Access Compliance Report Public Rights-of-Way (Curb Ramps)

Main Street: NARROW_CANYON_RD		Cross Street: CLARIN_ST		Location:	N
ADA ID: RPRK211028140921	Ramp Type:Type 1 - Perpendicular	Initial Pass/Fail: Fail	Overall Compliance: No	Severity Score:	2
Codes/Mitigation Info/Possible Solution			Field Measurements/Component Compliance

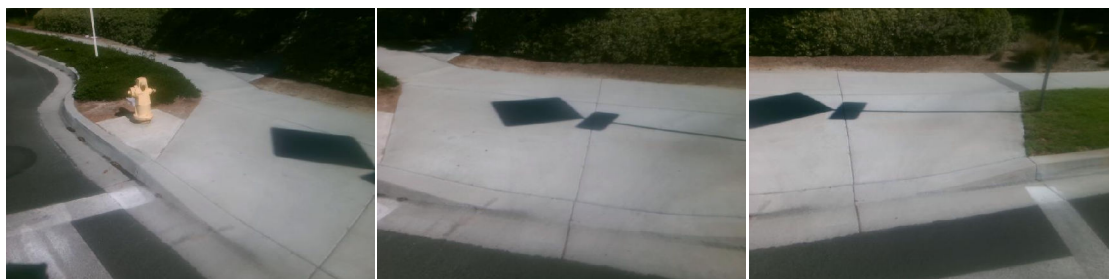
R304.2.2, R204.3, R304.5.3, STD 1115

Remove & Replace Entire Ramp.
